WORKING PAPER

TECHNICAL ASSISTANCE TO THE
U.S. ENVIRONMENTAL PROTECTION AGENCY
ON 40 CFR PART 191

U.S. Department of Energy

May 11, 1992

Figure 4-1. Containment Requirements in the Three-Bucket Approach

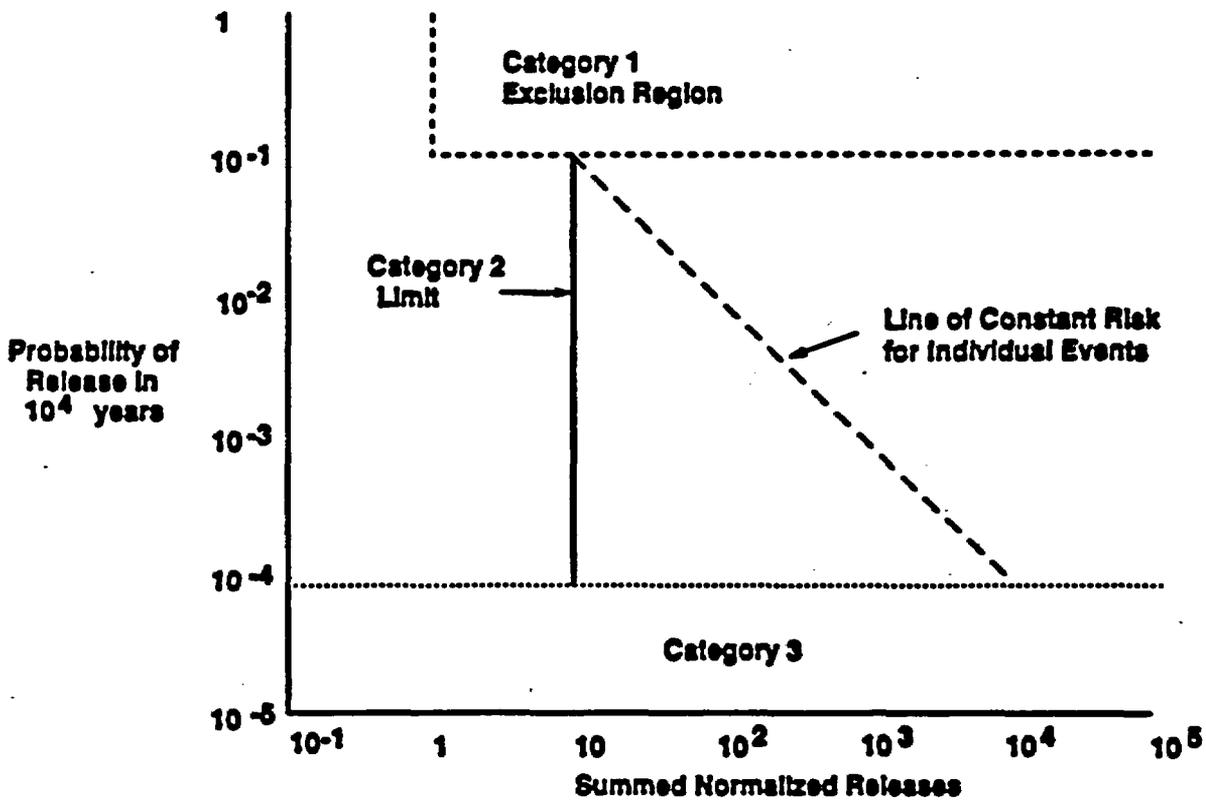
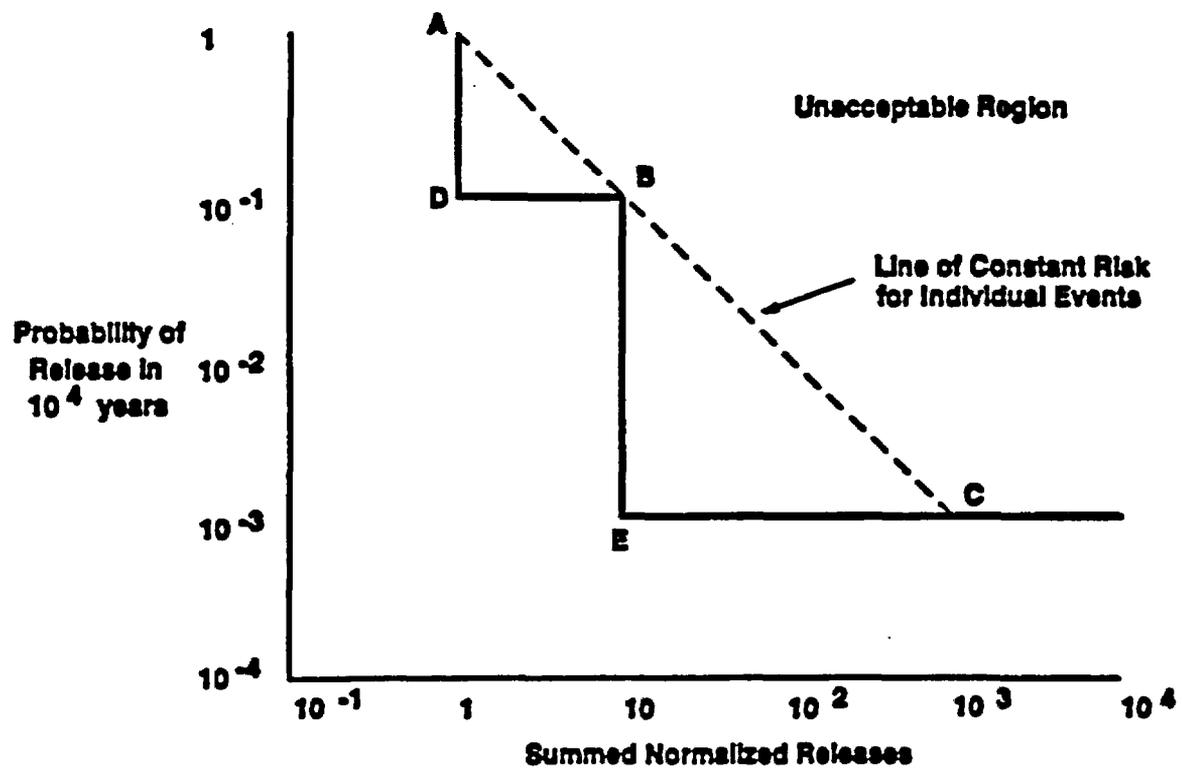
This approach has some problems that must be resolved before it could replace the present containment requirements. The system CCDF in category 1 would be incomplete, and the upper level of probability would always be less than 1. Moreover, the upper level of this incomplete system CCDF also would be different for each repository, making the requirement inconsistent. One partial solution would be to normalize the incomplete system CCDF so that it would be complete for anticipated events. The requirement would still be inconsistent and it would not be traceable to the fundamental standard that applies to the entire disposal system, not just to some events. If, to overcome this difficulty, all events were included in the category 1 CCDF to make it complete, the need for precise probability estimates would be the same as the present approach.

Another problem is the nonuniformity of category 2. As can be seen in Figure 4-1, the proposed requirement is 1,000 times as restrictive for events with probabilities of 0.0001 as for events with probabilities of 0.1. This nonuniformity could be eliminated by using the line of constant risk in Figure 4-1 as the category 2 limit. The accuracy requirements for probability estimates would then be uniform for the entire category.

The NRC staff has claimed that the "three-bucket approach" may simplify licensing or permitting of repositories, but the concept and some definitions need clarification, and some modifications are needed to reduce inconsistencies and nonuniformities. It is not clear that categories 1 and 2 can be shown to fulfill the total-system risk requirements of the fundamental criterion.
